5 October 2010

**Subject: Technical Review Comments
Environmental Impact Report
Eagle Crest Energy Company Eagle Mountain Pumped Storage Project**

FIGURE 2
ACCUMULATION OF TOTAL DISSOLVED SOLIDS AND ARSENIC
EAGLE MOUNTAIN PUMPED STORAGE PROJECT

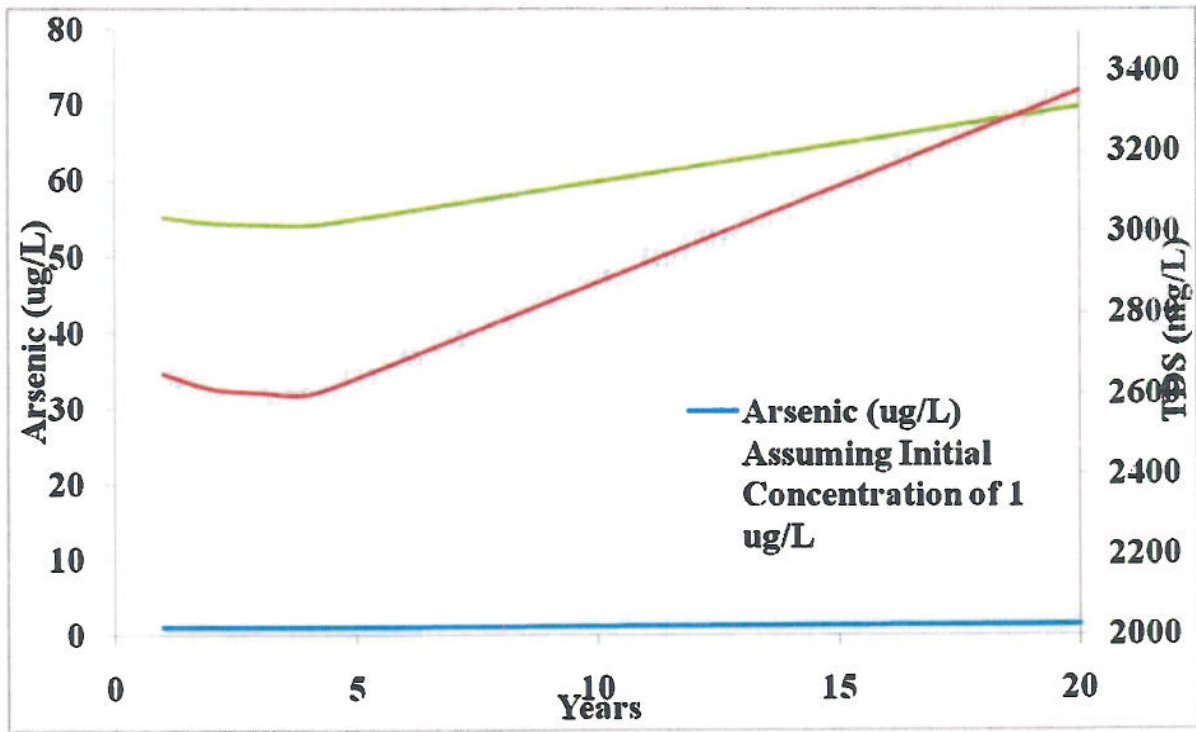
No specific groundwater characterization data are provided in the TM, with the exception that the groundwater supply is expected to contain 2,400 ppm of TDS. Calculations indicate that, despite the RO system's removal of TDS, the TDS concentration in the reservoir will increase over time (Figure 2). Similarly, if hazardous constituents (e.g., arsenic, selenium, mercury, etc.) should be present in the water then their concentrations will also increase over time.

Arsenic is a hazardous constituent that is often a concern in California groundwater supplies. The Project appears to be in a region of California that typically contains between 1 and 50 micrograms per liter ($\mu\text{g/L}$) of arsenic (Figure 3). For reference, the Maximum Contaminant Level (MCL) for arsenic in drinking water is 10 $\mu\text{g/L}$. As

shown in Figure 2, the concentrations will increase over time and may exceed the MCL already, depending on the pumped groundwater quality.
